**Packet Guide**  
**City of Charlottesville**  
**Board of Architectural Review**  
**Regular Meeting**  
**August 16, 2022, 4:00 p.m. (pre-meeting) and 5:30 p.m.**  
**Hybrid Meeting (In-person at CitySpace and virtual via Zoom)**

**Special meeting: Review materials for Courts Expansion, Levy Site. No action to be taken.**

Project: New courthouse building (at Levy Building)

### Flange on metal grate

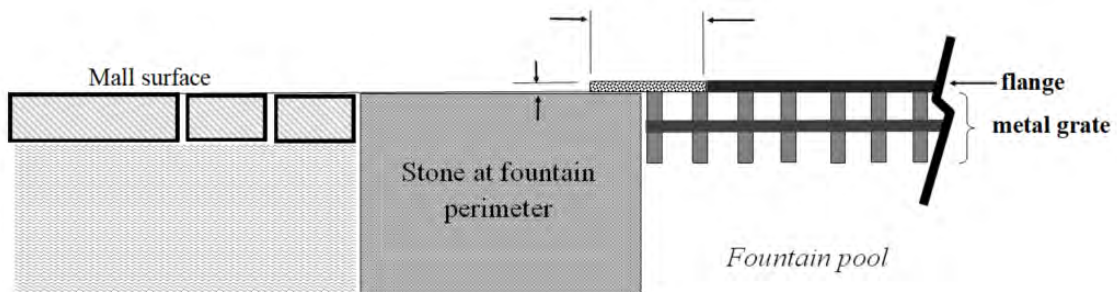
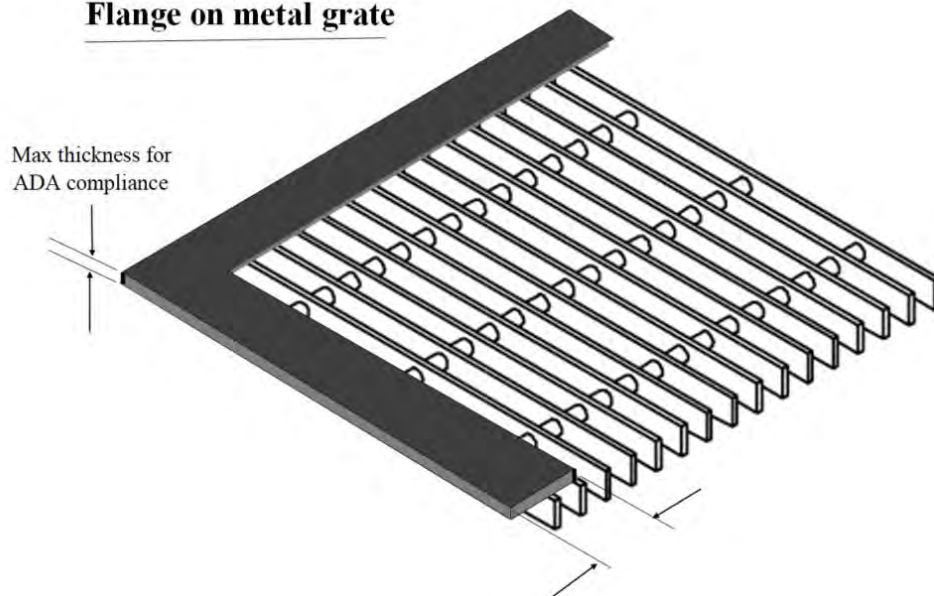
[Sketches by BAR staff. For discussion only.]

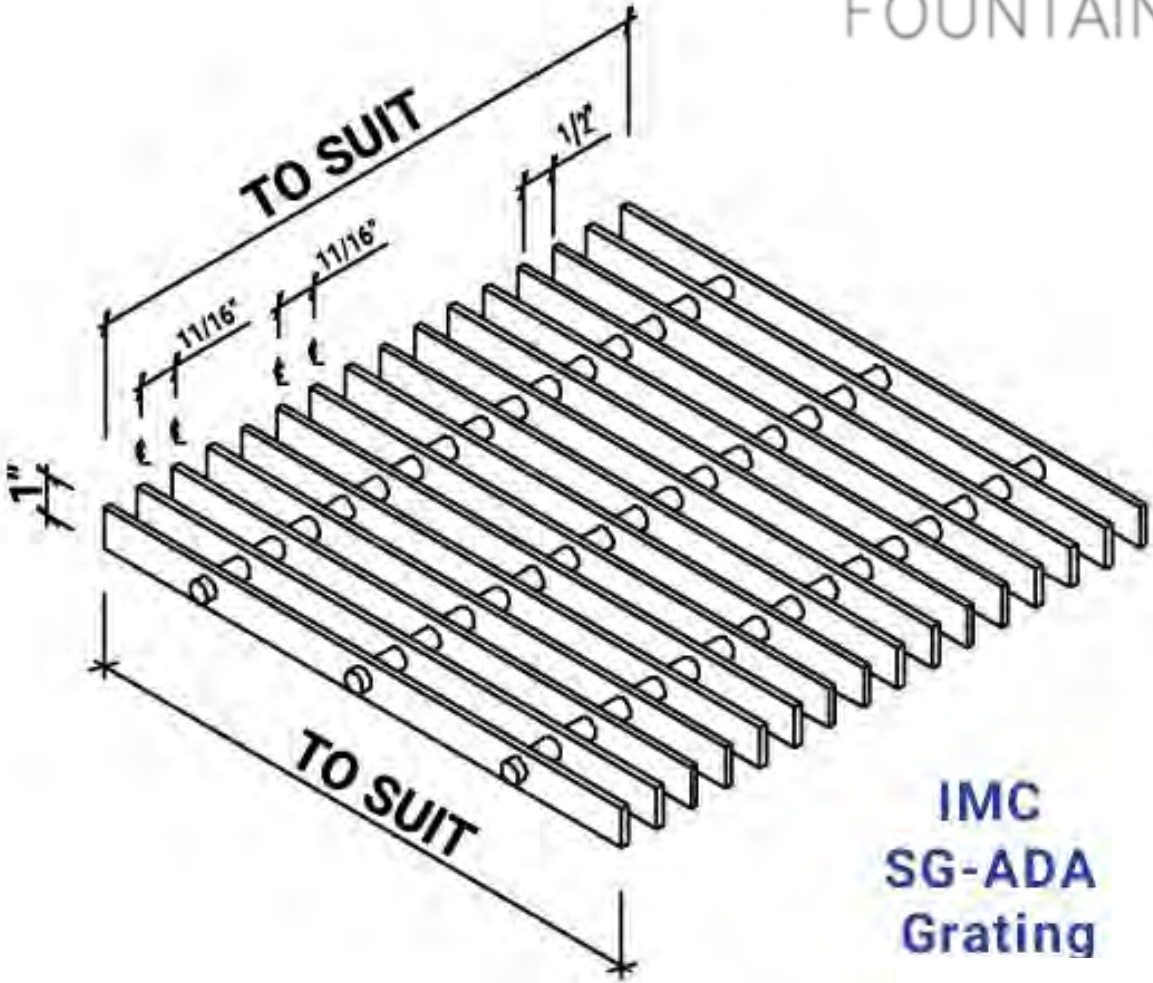
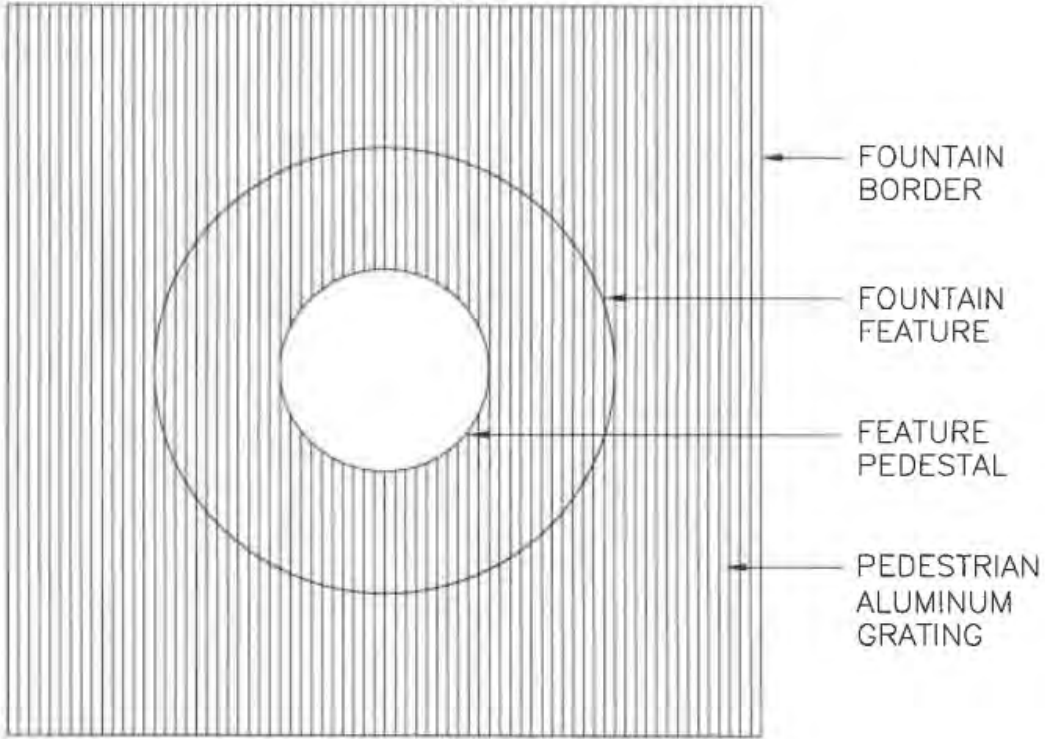
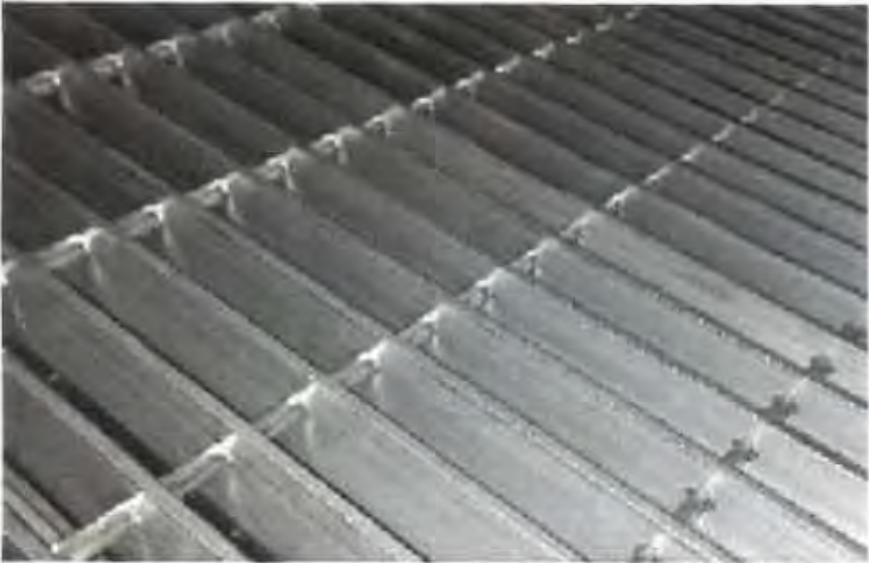
Unless a viable, available alternative is proposed, staff recommends the BAR approve the grates, but with two conditions:
